Protection system risks during ESR Tests

July 2026

Restoration Service tests

Energising Clean bar

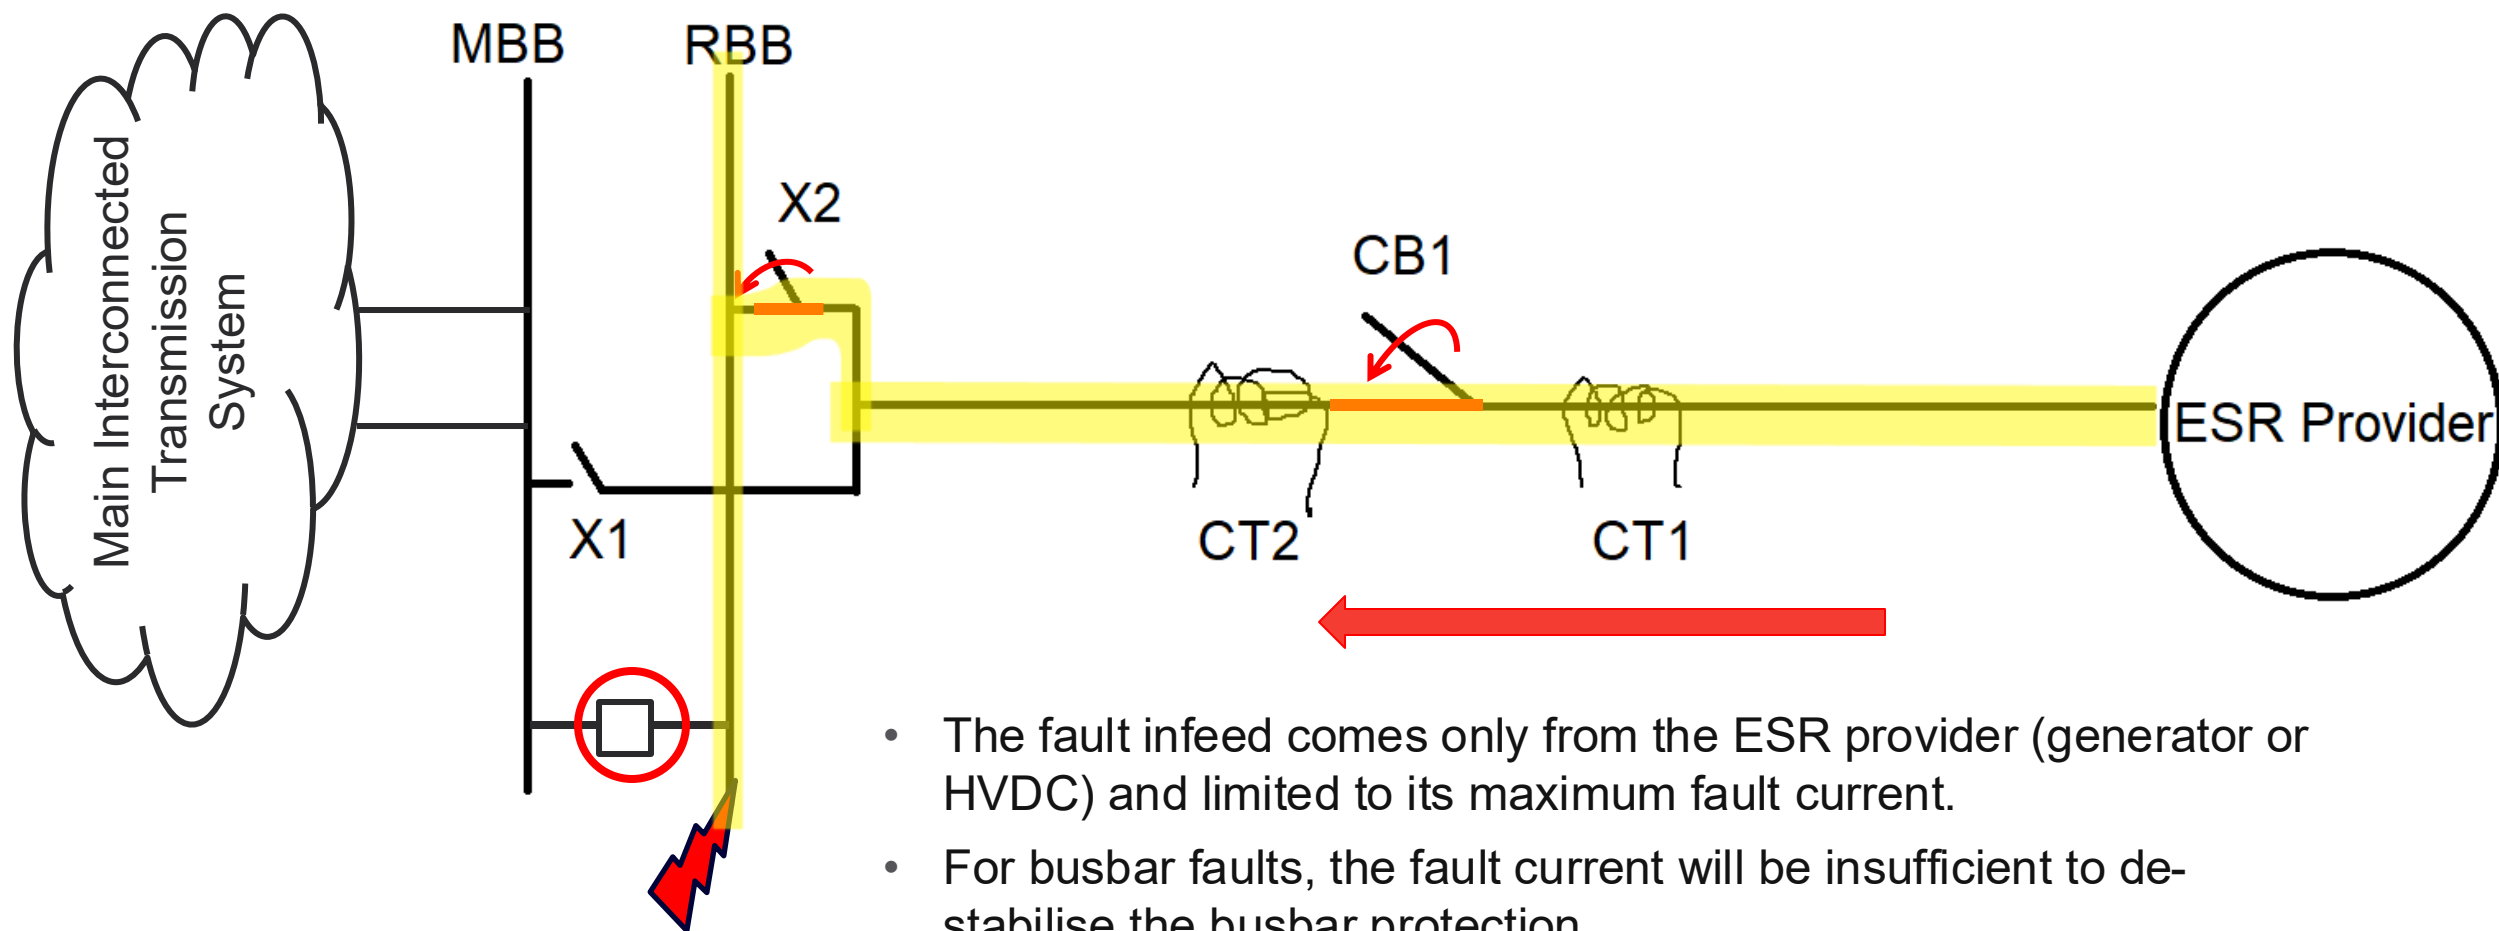
- The fault infeed comes only from the ESR provider (generator or HVDC) and limited to its maximum fault current.
- For busbar faults, the fault current will be insufficient to destabilise the busbar protection.
- Reducing the busbar protection sensitivity would affect the reliability of the live system (i.e. MBB).
